**RE: 1 Tabalum Road, Balgowlah Heights 2093**

**DA 2019/1180**

**LETTER OF OBJECTION**

**LETTER OF OBJECTION**

**Actual 8.5m Max Build Height [red dot] & 7.0m Max Wall Heights [blue dot], massive basement in solid blue close to boundary.**

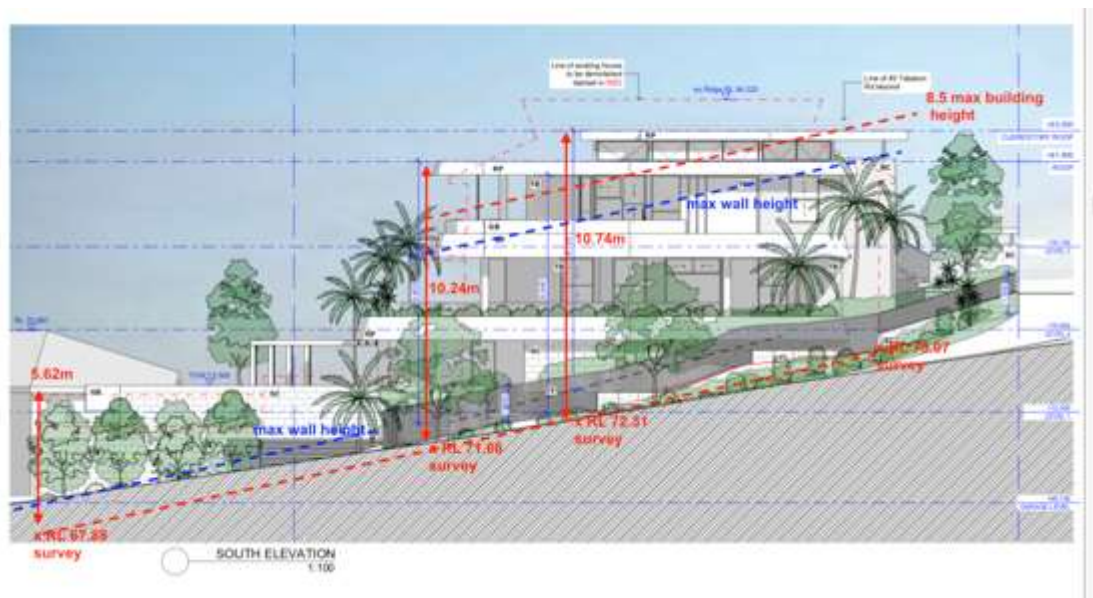
The proposed building heights rise to 10.74m [clerestory roof] and 9.32m [NW] and 10.24m [SW] along the western façade, as noted above. This is substantially higher than the drawings suggest, and indeed substantially higher than the SEE states.

From the above sketch overlay to the northern elevation, we have positioned from the Applicant's Survey the survey mark heights at the corners of the existing dwelling of the *Ground Levels [Existing]* and superimposed those heights onto the northern elevation.

Council can easily see that the existing house is shown by the Applicant in a light dotted red line, and the two *Ground Levels [Existing]* survey marks at RL 75.61, RL 72.58 & RL 71.95 at the corner of the existing house are then superimposed on the sketch drawing.

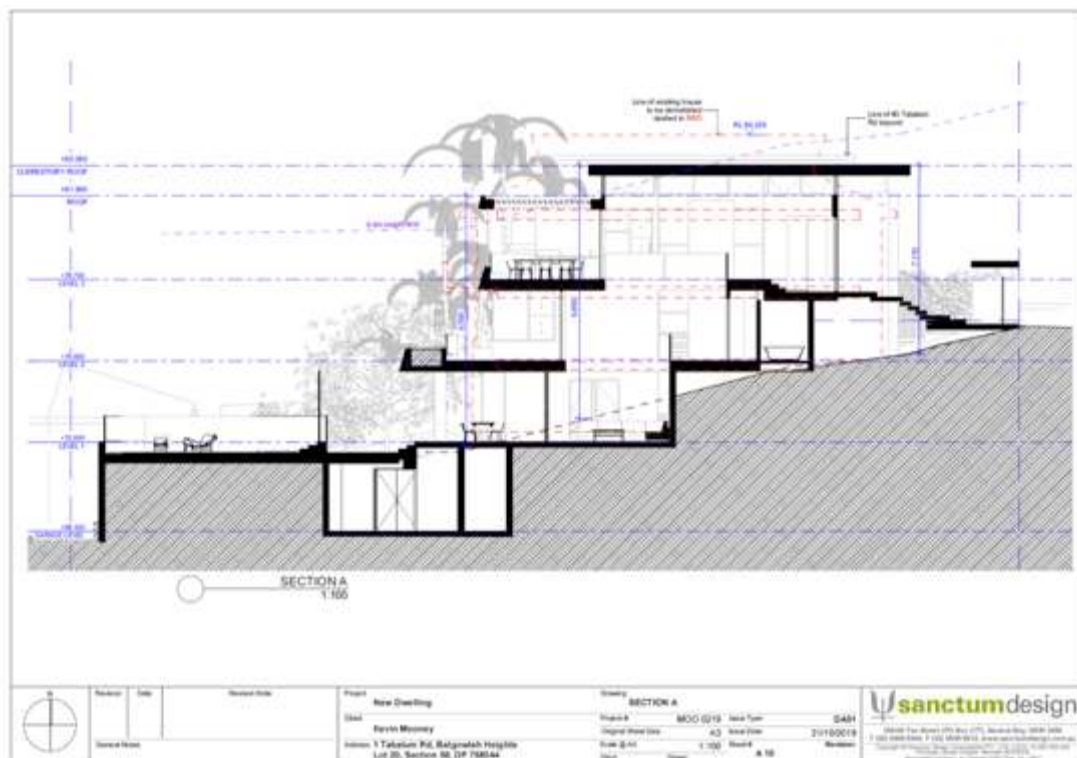
We are of the view that all 3D sketches are potentially incorrect and they cannot be relied upon.

If the Applicant has used grossly misleading *Ground Levels [Existing]*, we strongly suspect that all images are distorted to give a more favourable outcome to the Applicant.

Based upon these heights being incorrectly presented, we ask Council to request that the Applicant position 'Height Poles' to define the non-compliant building height and building envelope to both the east and west, and to have these poles properly measured by the surveyor.

Height poles must be erected to define the top of balustrade to the proposed western deck facing 6 Cutler.

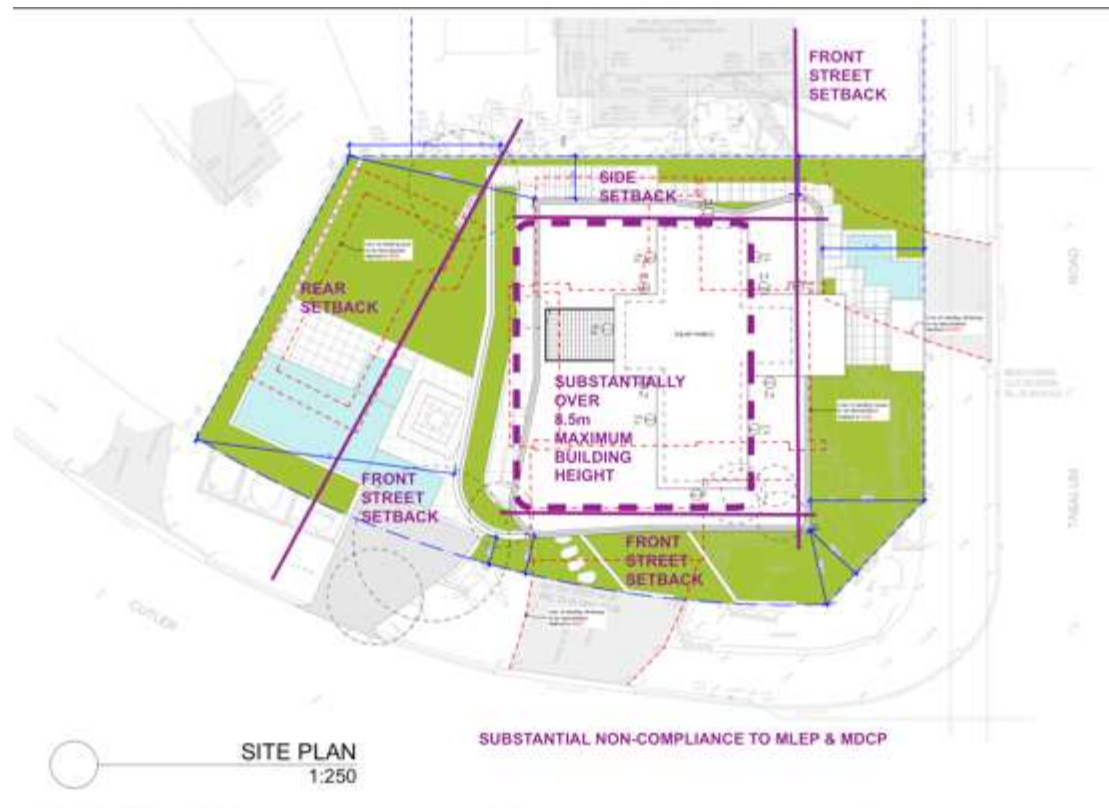
Present building heights, wall heights, and number of storey totally inconsistent with the controls and neighbouring development

Do not control the bulk and scale of the building

Do not ensure the height and bulk has regard to the topography

The proposals are 2.24m over the maximum Height of Buildings allowed on this site. This represents a >26% non-compliance.

## SUBSTANTIAL NON-COMPLIANCE TO MLEP & MDCP

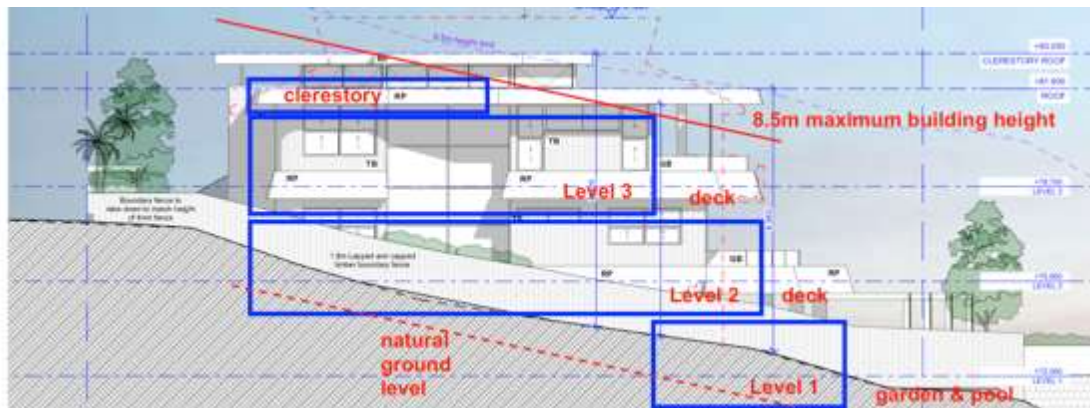
There is no valid reason why the new building cannot be contained within maximum 8.5m building heights, maximum 7m wall heights, and generally two storey rather than 4 storey.

There is no valid reason why a 5.6m high deck is proposed on the boundary to 6 Cutler and onto the Cutler st frontage contrary to multiple planning controls.

The more skilful design solution should have been to control the maximum 8.5m building height to the south-western edge boundary at Level 3, and to reduce the floor plates at 3.1m storey heights, to achieve a compliant envelope. Wall heights reduced to 7m, compliant front and side setbacks, and the building profile stepped down the slope to achieve a two storey configuration. That is the expectation of a design outcome on this site, in accordance with the MLEP & MDCP.

The garden, pool and garage should have been designed in the western rear setback zone at *Ground Levels [Existing]*.

**‘More Skilful Design’:** max. 8.5m building height, three stepped floor plates following the slope, 2 storey configuration, maximises FSR. Garage under the dwelling. Level street entry to Level 3.

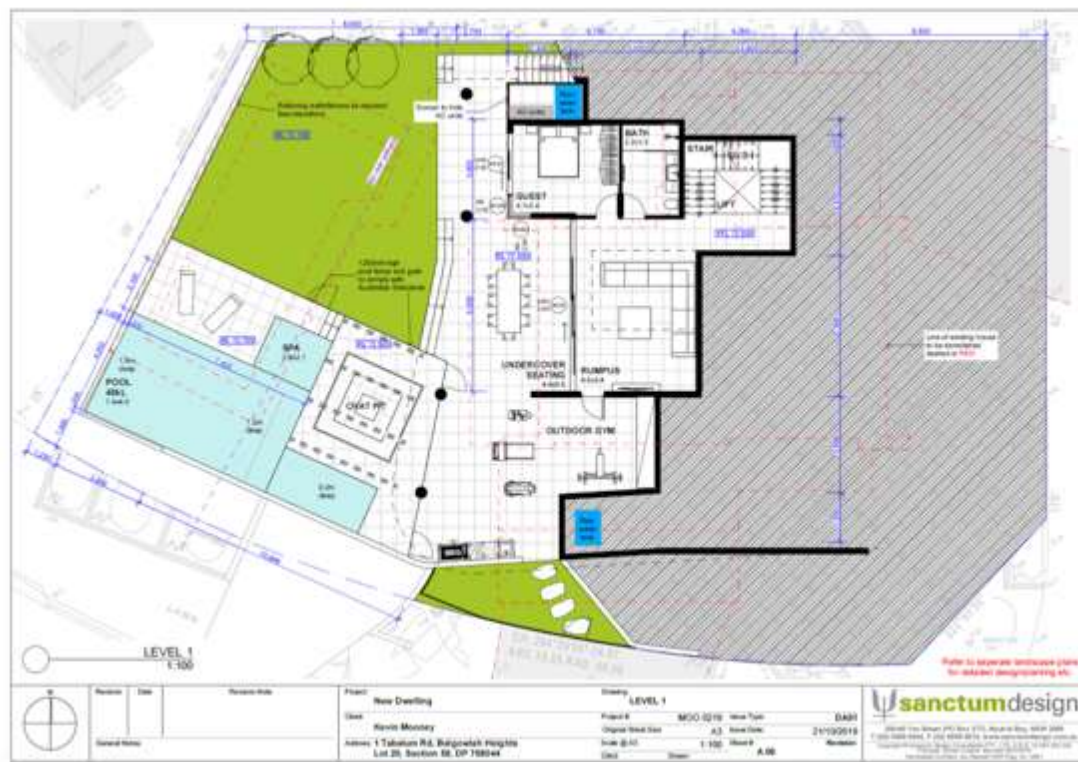
We are somewhat astounded that the Applicant would propose a > 5.6m high deck onto the streetscape and our property, with an elevated pool, causing our property to suffer from visual bulk blight, massive privacy issues, and excessive mid season equinox overshadowing, rather than a soft landscape zone at *Ground Levels [Existing]* to soften the interface between our residence and the proposed residence.

This is a devastating impact on our property, and we ask Council to have the Applicant submit Amended Plans to completely change the concept that he is following or refuse the DA.

- No works to the west of the proposed dwelling is approved.
- The garden is to follow *Ground Levels [Existing]* from RL 71.66 [south survey] RL 71.92 [north survey] or from revised Level 1 at RL 70.8 [ANS 01] to slope to boundary to 6 Cutler at c. RL 68.87 [survey on subject site], with obscured glass privacy screens at 1.8m high along the 17m boundary with #6 Cutler,

- Along the 17m boundary with #6 Cutler, plant mature 75 lit pot size, 9 no. native screening trees (*Acmena smithii Firesreen*), at 2m centers, prune annually to align viewing sightline from proposed Level 3 upper level deck viewing height at 1.4m above FFL to window head at #6 Cutler, organic slow release fertiliser during growing season, with drip irrigation.

- Along the 17m boundary with #6 Cutler, at the boundary line, build a solid 1.8m high boundary fence, with the finished side facing #6 Cutler
- The garage to be positioned under the proposed dwelling at Level 1, Garage at RL 70.8 and accessed from SW corner of property, with existing crossover at RL 71.28 [survey] location.

- New details to be submitted to NBC for approval.

**Level 1: showing Pool @ RL 72.1, <1.7m from Cutler Road frontage, <1.0m from 6 Cutler boundary, and elevated 4m above *Ground Levels [Existing]* @ RL 68.18**

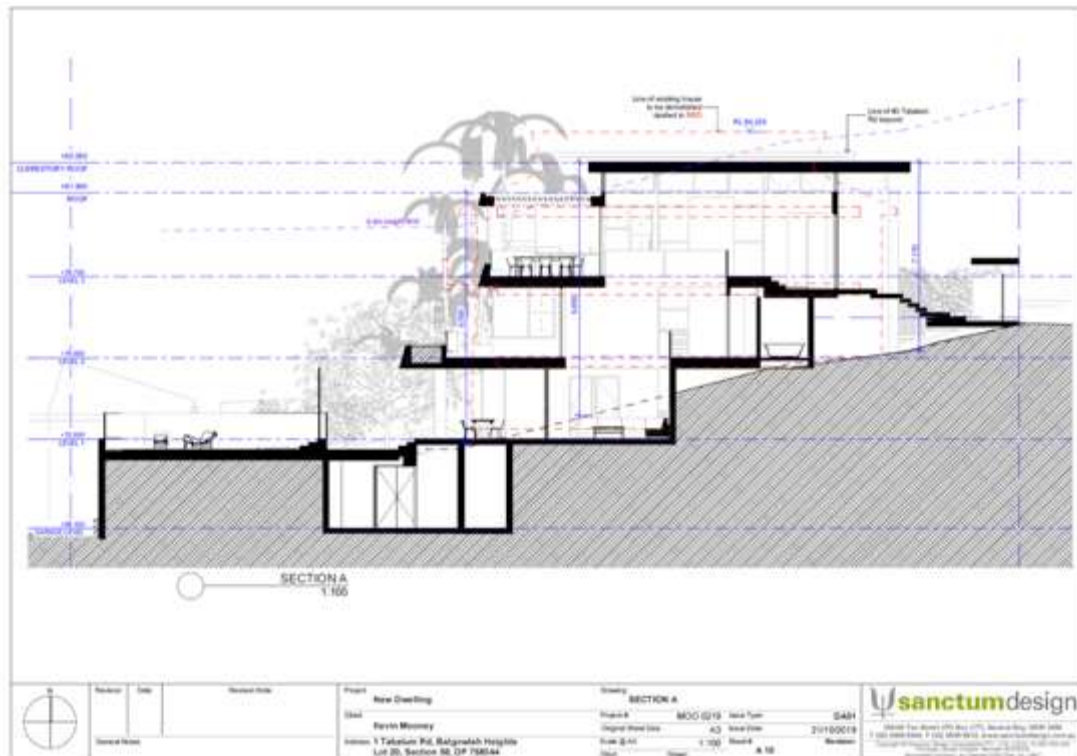
5m high Deck set <1m from 6 Cutler boundary in the rear setback zone

Alternative New Landscape Garden to follow *Ground Levels [Existing]*. Pool to MDCP controls set within landscape at ngl grades from Level 1 to RL 68.87. Garaging at Level 1 is similar location to existing. New stair entry passageway from garage. Delete entire 6m deep basement and 4m high pool and 4m+ high decks adjacent 6 Cutler. New crossover.

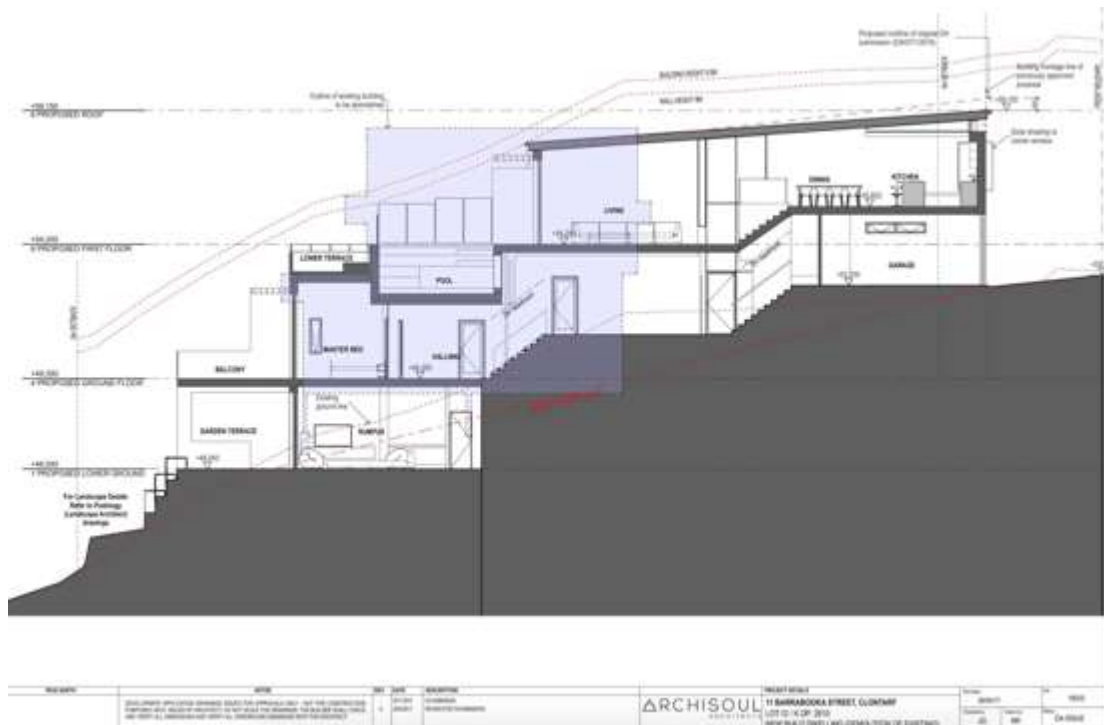
The SEE states: *'The proposal has three levels but in reality, only presents as*

*two storeys on elevation.*' This is incorrect. The Cutler Road elevation clearly represents 3 storey with a 10.4m & 10.7m building height. The western elevation viewable from the Cutler Road shows clearly 3 storey without any stepping back to follow the slope.
